Intersection ID: 48166	Main Street: NORTHLAKE_MALL_DR	Cross Street: NORTHLAKE_CENTRE_PY	Location:	SW
ADA ID: E7DCDC EE BF72	Ramp Type: Perp	Initial Pass/Fail: Fail	Overall Compliance: No	Severity Score: 13.75

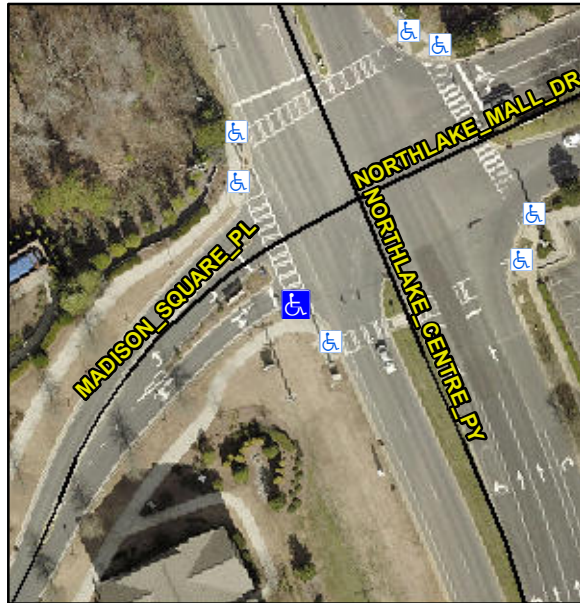
**Not Found, R304.2.2, R304.5.3**

Compliance	Description	Data	Compliance	Description	Data
N/A	Ramp Length (in)	85.0	No	Ramp Slope (%)	8.4
Yes	Ramp Width (in)	48.0	No	Ramp XSlope (%)	3.1
N/A	Flare Type LT	N/A	N/A	Flare Type RT	N/A
N/A	Flare Slope LT (%)	N/A	N/A	Flare Slope RT (%)	N/A
N/A	Flare Traversable LT?	N/A	N/A	Flare Traversable RT?	N/A
N/A	Landing Length (in)	N/A	N/A	DWS Provided?	N/A
N/A	Landing Width (in)	N/A	N/A	DWS Contrast?	N/A
N/A	Landing Slope (%)	N/A	N/A	DWS Length (in)	N/A
N/A	Landing X Slope (%)	N/A	N/A	DWS Full Width?	N/A
N/A	Landing Curb? (Y/N)	N/A	N/A	DWS Offset (in)	N/A
N/A	Shared Landing?	N/A			
N/A	Gutter Ponding?	N/A	N/A	Gutter Slope (%)	N/A
N/A	Gutter Lip Ht (in)	N/A	N/A	Gutter X Slope (%)	N/A
N/A	Painted X Walk1?	Yes	N/A	Painted X Walk2?	N/A
	X Walk 1 Direction	To NW		X Walk 2 Direction	N/A
N/A	X Walk 1 Width (in)	115.0	N/A	X Walk 2 Width (in)	N/A
	X Walk 1 Slope (%)	3.4		X Walk 2 Slope (%)	N/A
	X Walk 1 X Slope (%)	2.0		X Walk 2 X Slope (%)	N/A

### Remove & Replace Entire Ramp.
